Addendum #1

Attn: Estimator	Date: November 14, 2024
From: Lisa Donahue, Project Administrator	Pages: 58 (including cover page)
Re: Bullock Creek School District 2024 Bond Series 1	Project: 2025 Summer Projects HS/MS/Elem/Pine River/Floyd and Maintenance Building
CC:	Proj. #: A24907

Project: No. 24-120 2023 Bond – Series 1 2025 Improvements

Issue Date: November 14, 2024

NORTH
1/8" = 1'-0"
X01
RTU-B1 ENLARGED PLAN

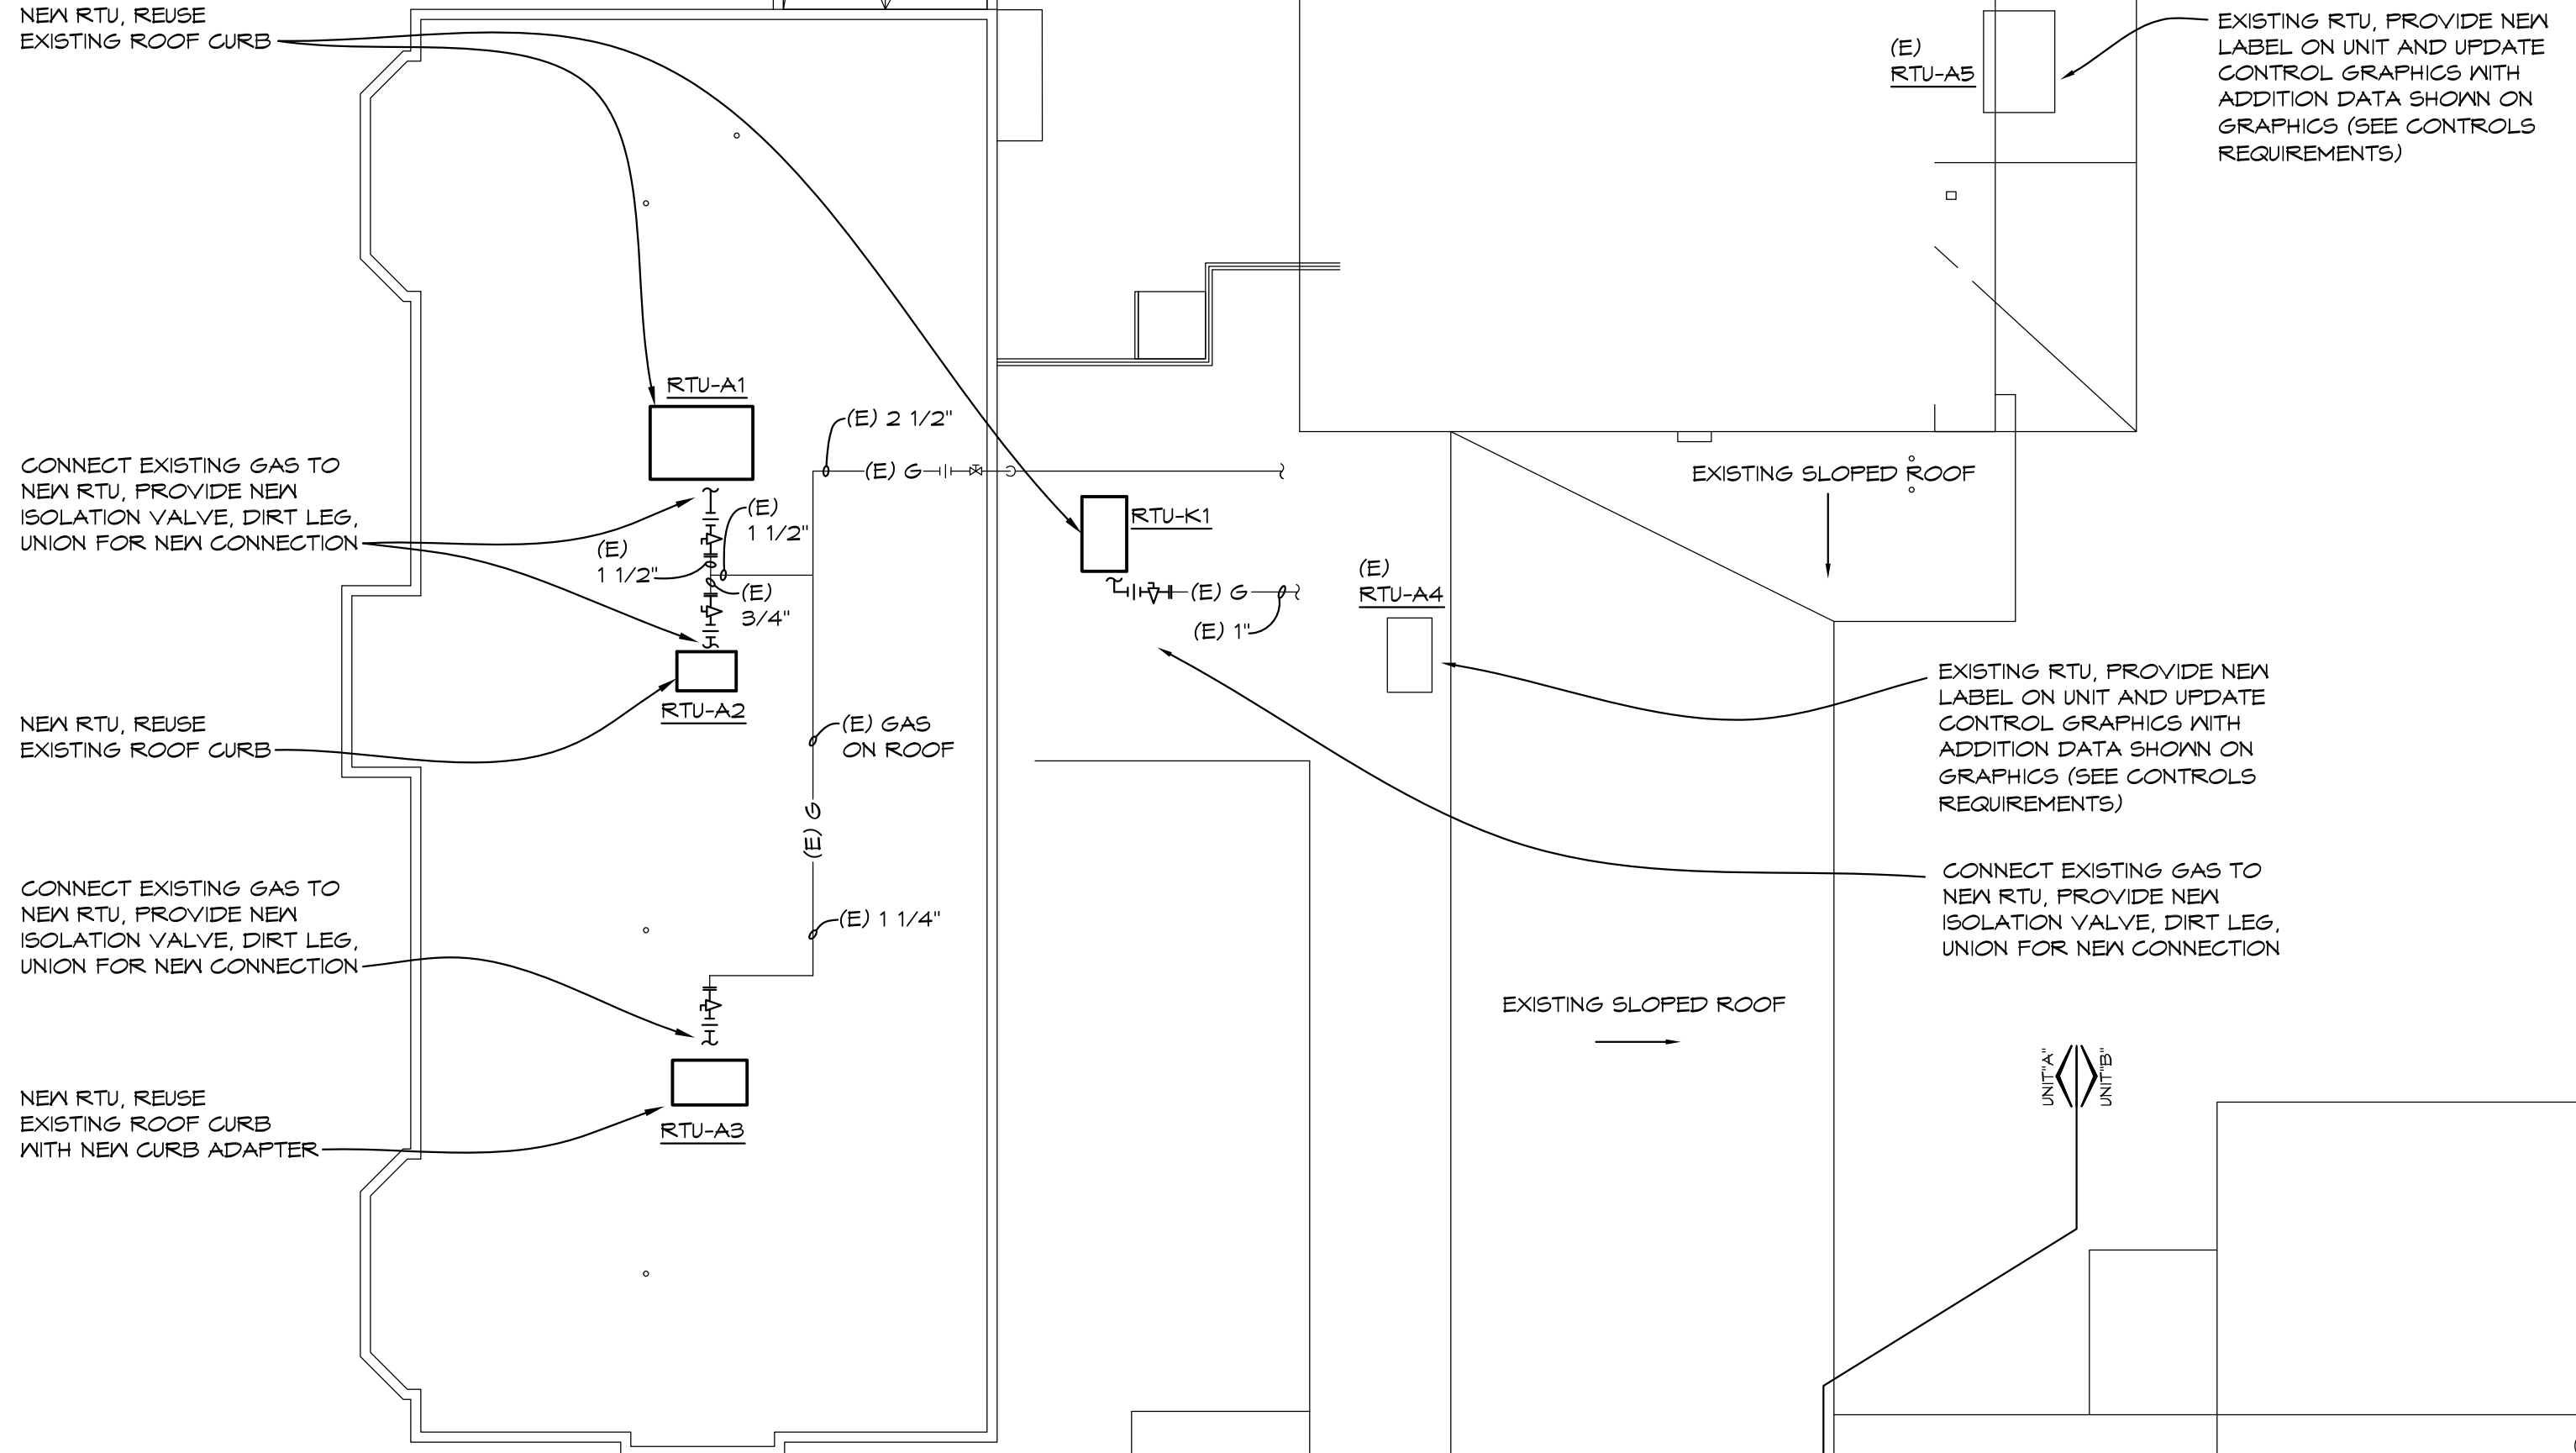
- Item #M1: Clarification for Sheet C-M101:
- a. Remove roof curb at heat recovery unit demolition. Coordinate with general trades/roofing contractor on infill of roofing insulation as part of new roof work.
- Item #M2: Raise existing 12x8 supply air ductwork on roof at RTU-B1 feeding 'teachers' lounge. Adjust drops for new roof curb heights. Provide insulation and support called out on plans.
- Item #M3: Raise existing gas line feeding RTU-B1 back to main line near RTU-B2 for new roofing work provide new nonpenetrating gas piping supports.
- Item #M4: Adjust 34X18 supply air duct penetration location as shown on Sheets C-M102 and C-M104. Coordinate with general trades for opening in wall.
